USNRC APPLICATION
SUA-1341 License Amendment
Ludeman Project
Converse County, WY

June 2013

80 Sand Potentiometric Map
Ludeman Regional Aquifer Test
Uranium One America
Converse County, Wyoming
Revised June 2013

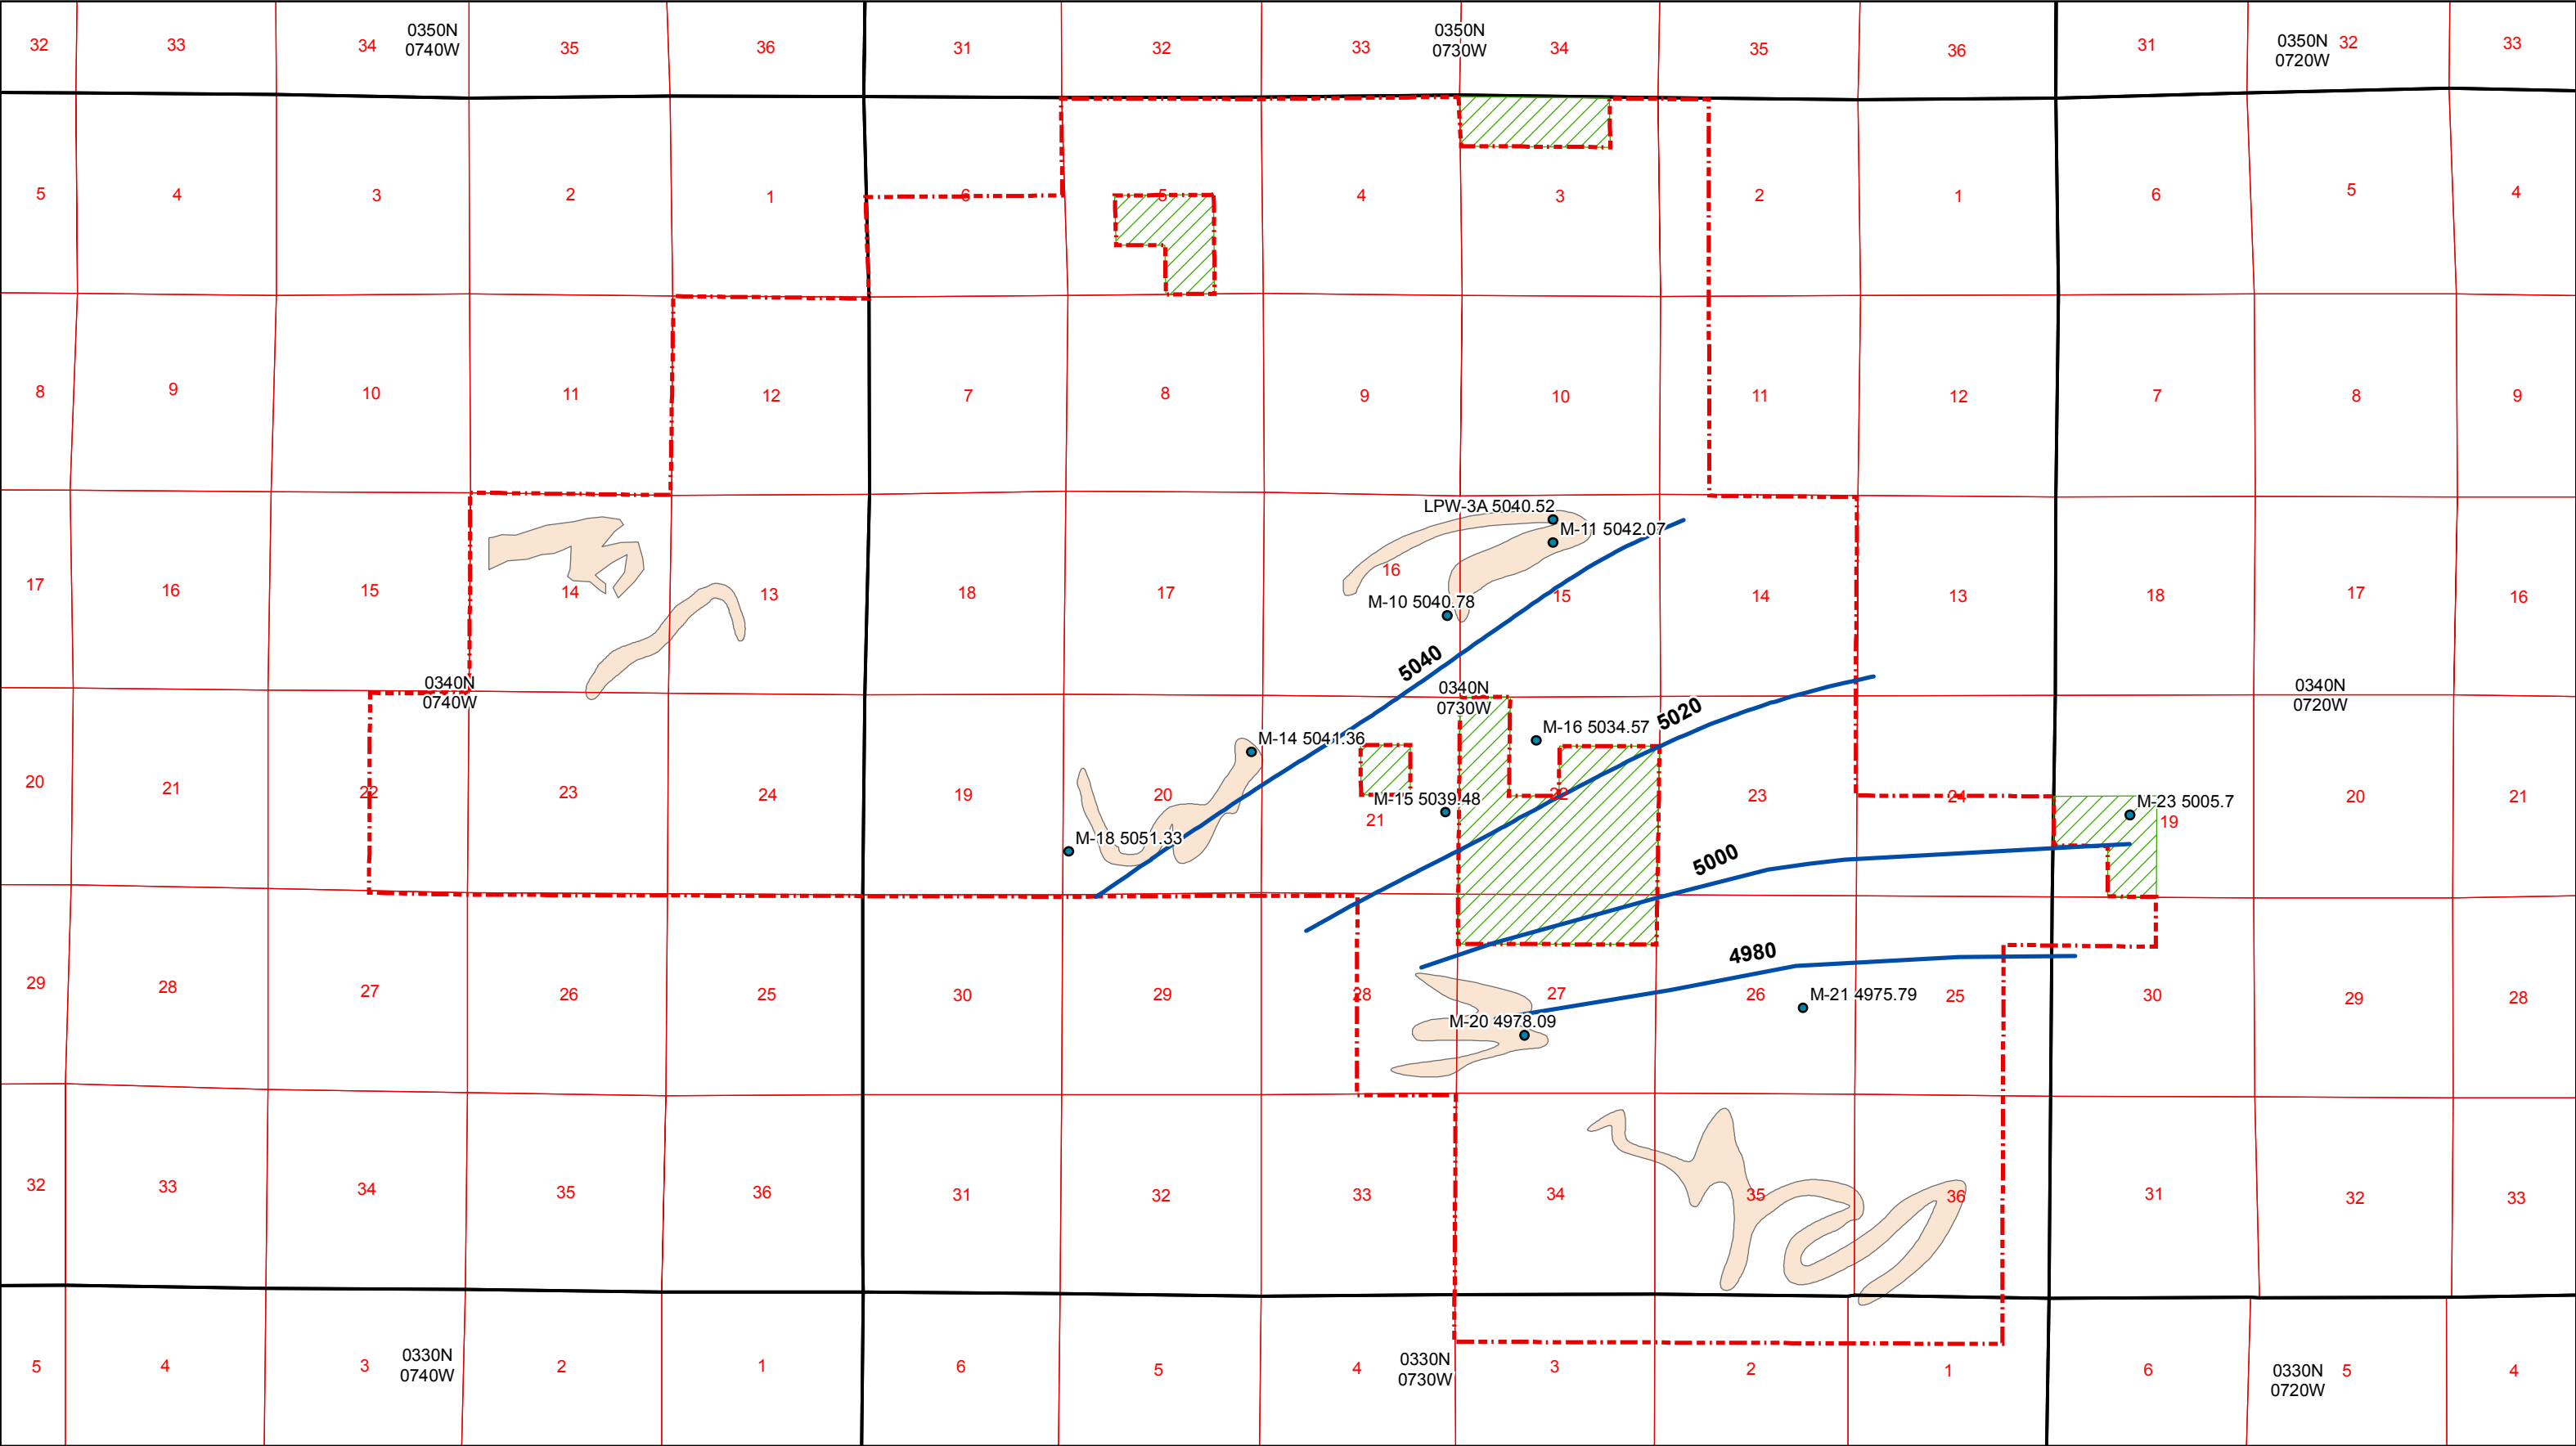
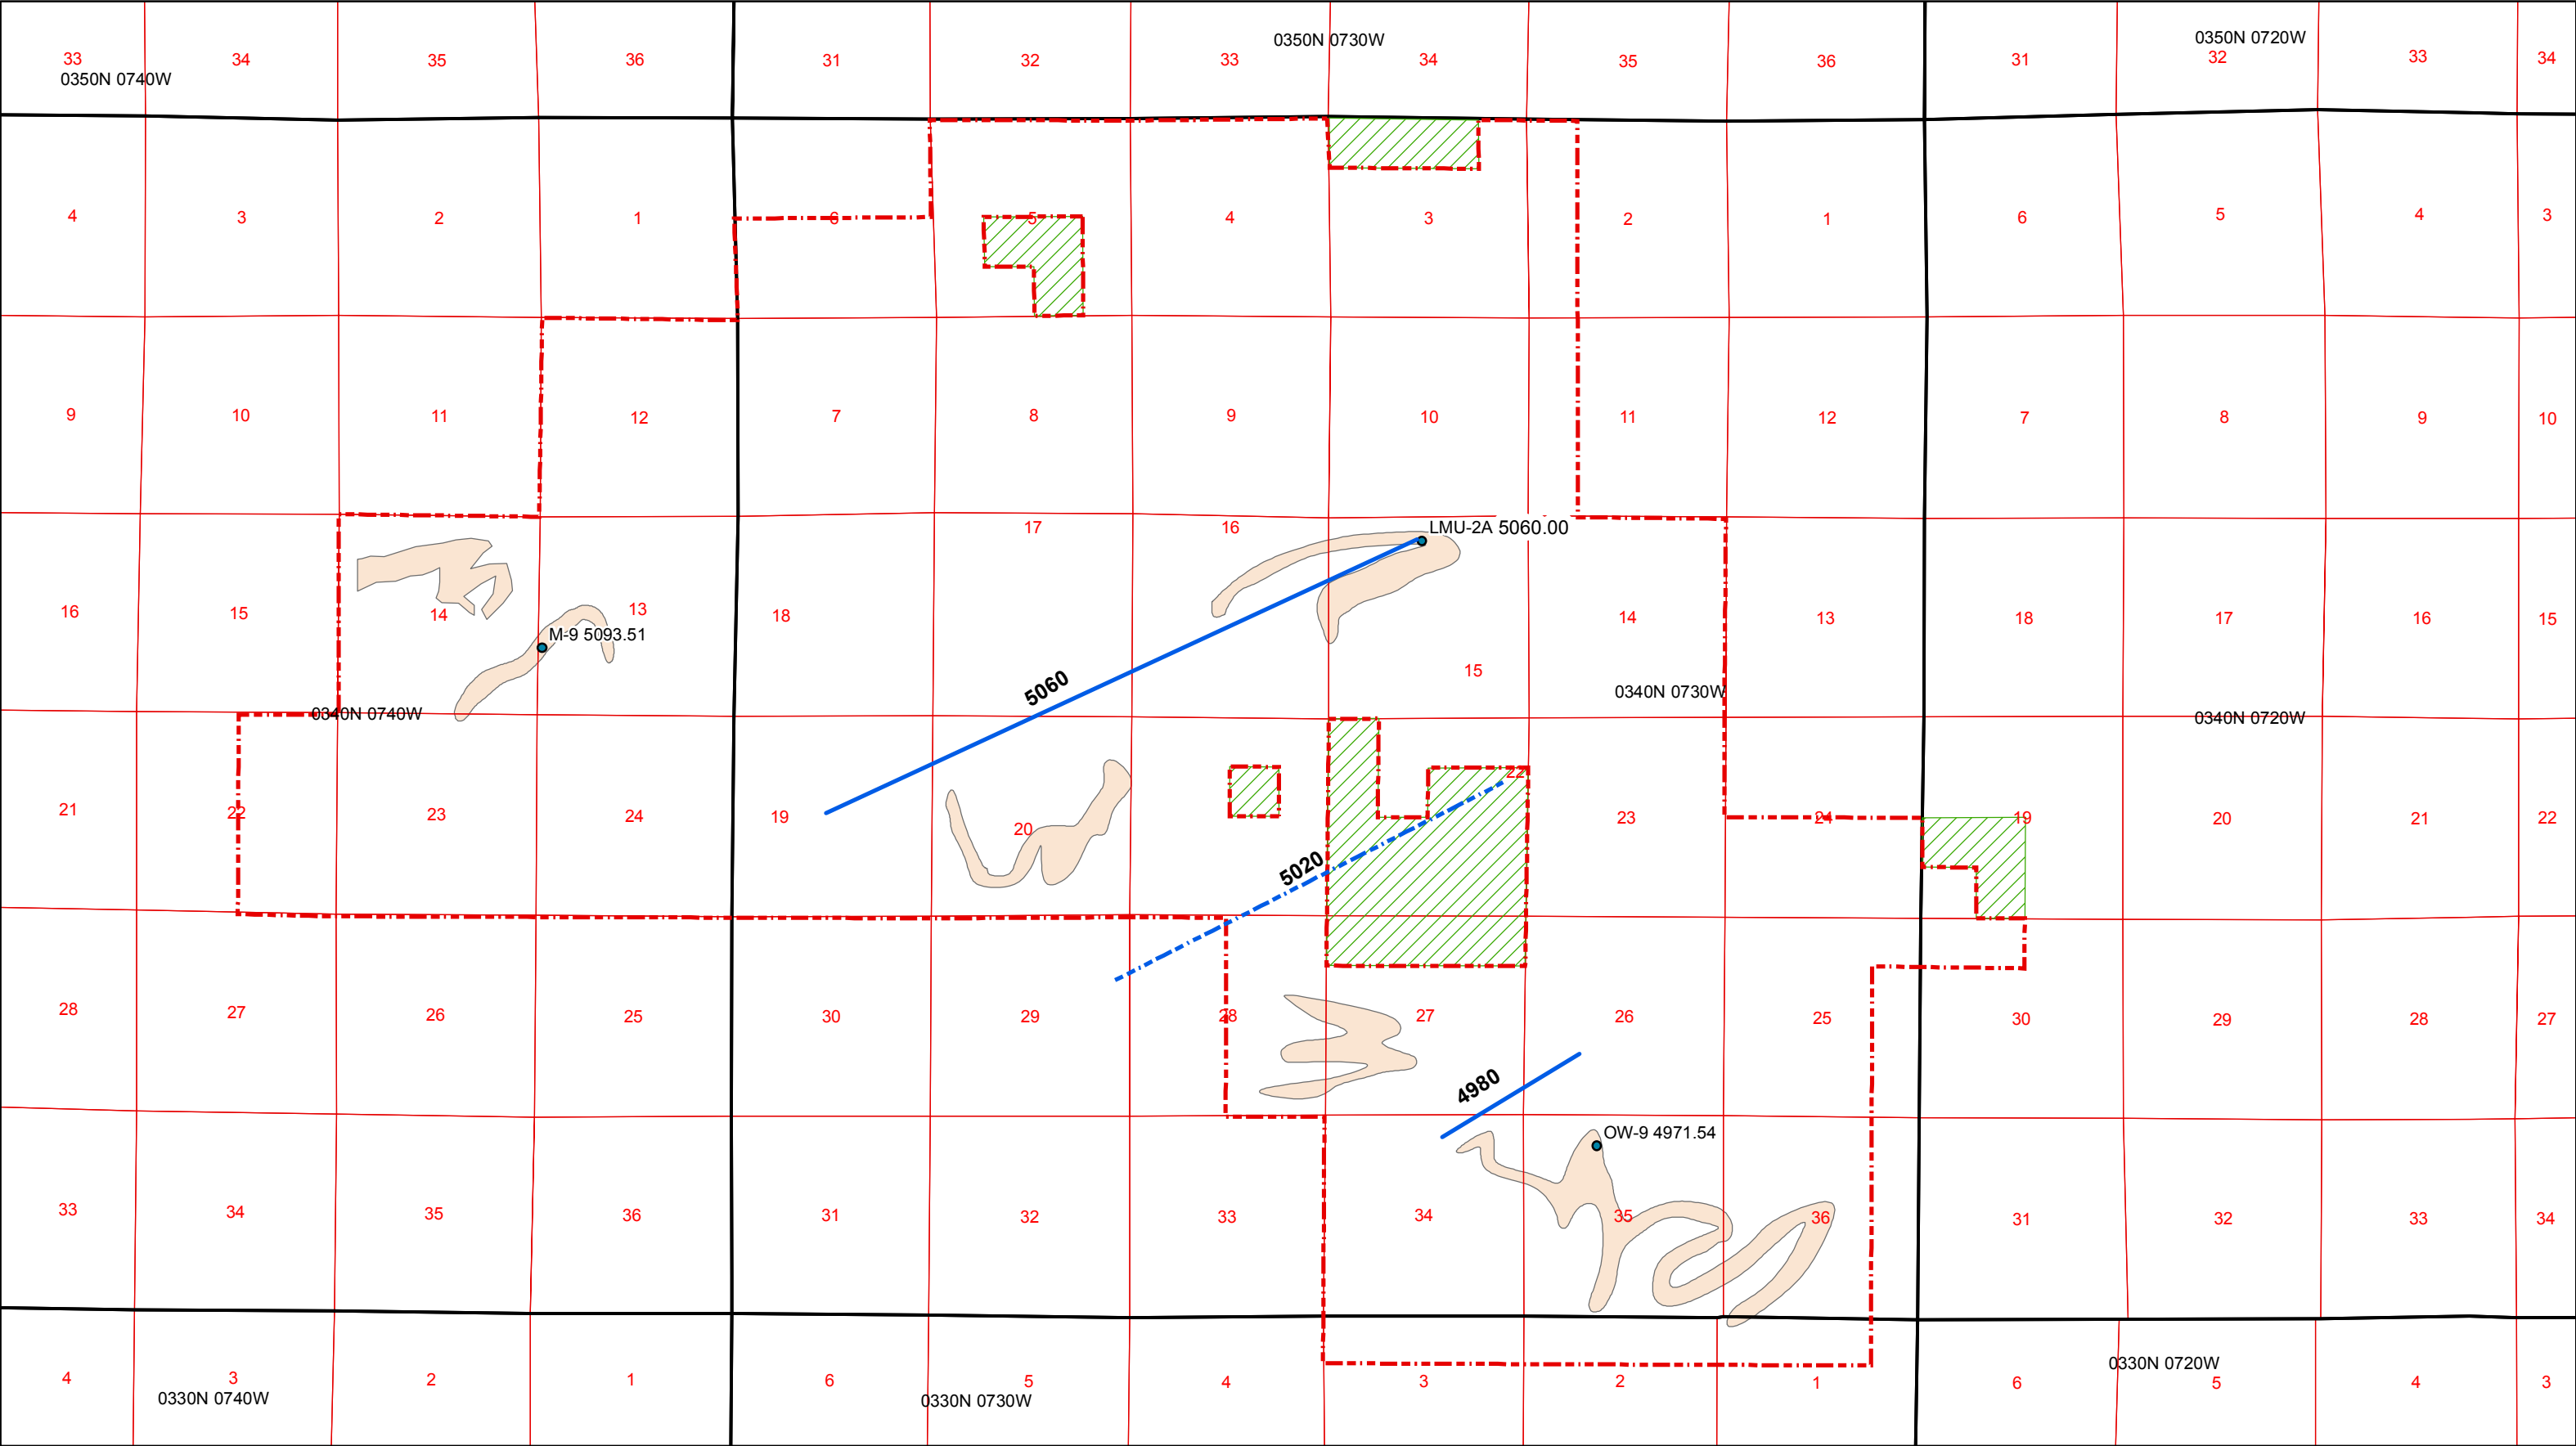
Staff evaluated the Addendum 2.7-C table “Summary of Monitoring Well Completions” and found the majority of the well top of casing (TOC) elevations in the tables were in conflict with well log ground surface elevations of the same wells provided in the cross sections in Figures 2.6-3 through 2.6-13. The table below presents the monitoring well top of casing elevations provided Addendum 2.7-C vs. the elevations provided on the cross sections. As can be seen in the table, there are often very large differences in the elevations. These differences call into question the aquifer water levels in mean sea level which were calculated based on the top of casing elevation. These water elevations are the basis for the potentiometric surfaces created for all the aquifers in the proposed license area. In addition, the selection of aquifer sand location is questionable if the well TOC elevation is inaccurate. Because of these errors, staff was unable to evaluate the potentiometric surfaces, ground water flow direction and magnitude for the Leuenberger, North Platte or Peterson Satellites. Staff is also unsure if Uranium One has made the appropriate identification for the location of the underlying sands and aquitards based on the elevation errors. Staff cannot evaluate or provide reasonable assurance for the safety of operations at any of the proposed satellites without correction of the elevations of these monitoring wells and all figures and calculations (e.g. sand top and thickness) which were based on them.

Uranium One should correct all monitoring well elevations noted to be in error on the table and correct all discussions, tables, maps, cross sections and isopachs which used the incorrect elevation information from these monitoring wells. In addition, Uranium One should ensure that all well surface elevations presented in the application are accurate and all calculations based on them are also accurate. Staff is especially concerned about the correction of the elevation of the overlying aquifer sand, ore zone aquifer sand, underlying aquifer sand and associated aquitards at each satellite.

Additionally, staff is very concerned about the potentiometric surfaces and vertical gradients between aquifers which were calculated based on these elevations. Staff notes that anomalous potentiometric surface mounds were associated with some of these elevation errors. Therefore, once corrections are made to the elevations, provide the corrected potentiometric surfaces and estimate the ground water flow magnitude and direction for all overlying aquifers, ore zone aquifers and underlying aquifers for the Leuenberger, North Platte, and Peterson Satellites. Uranium One should use available water levels from wells located within 2 km of the each satellite's proposed wellfields for these updated surfaces, not just the limited monitoring wells available to provide better estimates of ground water flow direction and magnitude.

Uranium One has updated the well elevations presented in Addendum 2.7-C Summary of Well Completions with survey data and subsequently the potentiometric maps. For the wells that did not have survey data available, NED elevations have been utilized. The review of the NED elevations versus the survey elevations showed that the NED data were quite close. Thus, in cases when new survey data were not available, the NED data should provide a good approximation of elevation. The cross sections and isopachs will not require updates as they utilized the survey data to develop the figures.

The updated potentiometric maps are shown below.
